ENGINEERING INSTRUCTION

NEW YORK STATE DEPARTMENT OF TRANSPORTATION

ECT: PRESSURE RELIEF JOINTS

Code: EI 87-16

PRESSURE RELIEF JOINT AT THE END OF
REINFORCED CONCRETE BRIDGE APPROACH SLAB

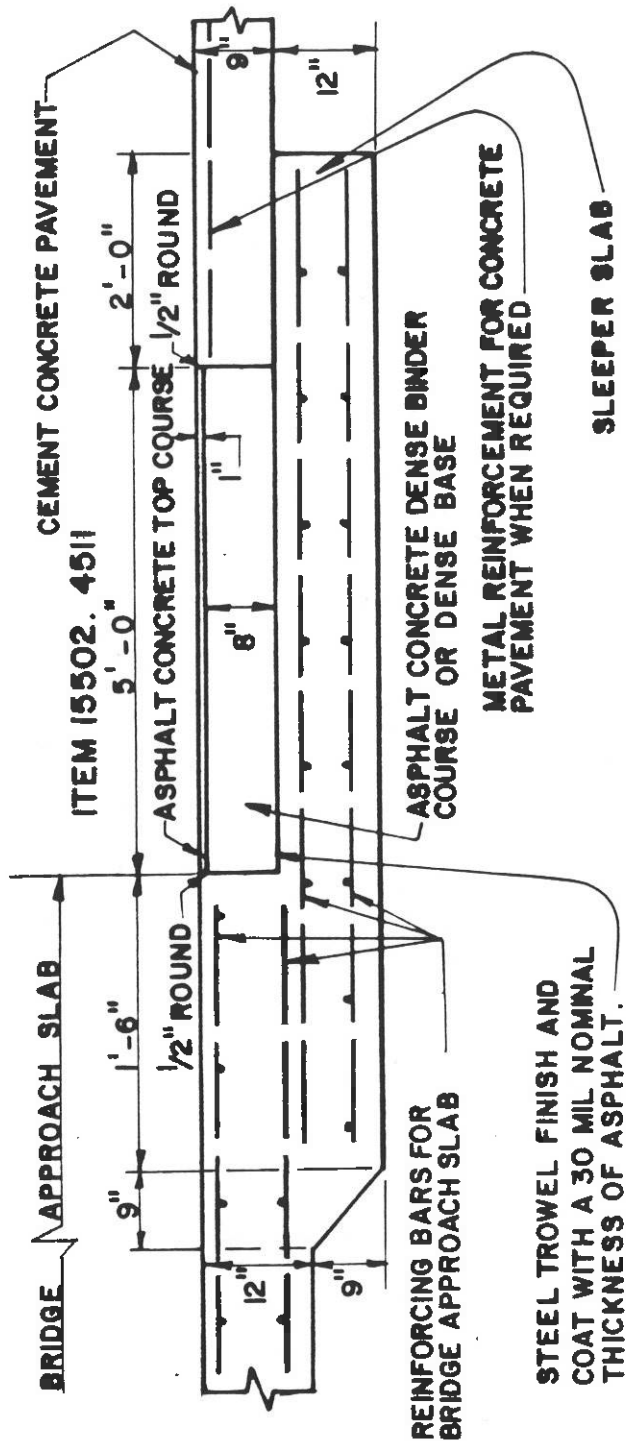
This specification modifies Item 15502.4510 by correcting asphalt material requirement subsections 702-02 and 702-03 (Jan. 2, 1981 Standard Specifications) to 702-0300 and 702-0500 of the January 2, 1985 Specifications. This change will have no affect on cost or material requirements.

The ends of the cement concrete shall be normal to the pavement centerline, perpendicular to the surface and lie in a straight line across the full width of the pavement. The upper edges shall be beveled as shown unless otherwise approved by the Engineer. The concrete along the joint shall be carefully consolidated and finished to a true surface. The surface of the concrete at the joint shall be tested with a 10 foot straight edge or template immediately after forming. Any variations from the true surface shall be corrected immediately.

The surface of the sleeper slab shall be steel trowelled until smooth and coated with 30 mils of asphalt bond breaker.

All vertical contact surfaces between asphalt concrete and portland cement concrete around the perimeter of the joint shall be painted with a uniform coating of Asphalt Emulsion. The application of the asphalt emulsion shall be made to a clean and dry surface and at a rate as ordered by the Engineer.

Type 1 Dense Base or Type 3 Dense Binder shall be placed and leveled in a manner approved by the Engineer. These mixes shall be placed to achieve a maximum compacted lift thickness of 4 inches. When the lifts of Dense Base or Dense Binder have been placed and compacted, a final lift of Type 6, 6F, 7 or 7F Top Course shall be placed and compacted so that it is level with the top of the pavement.
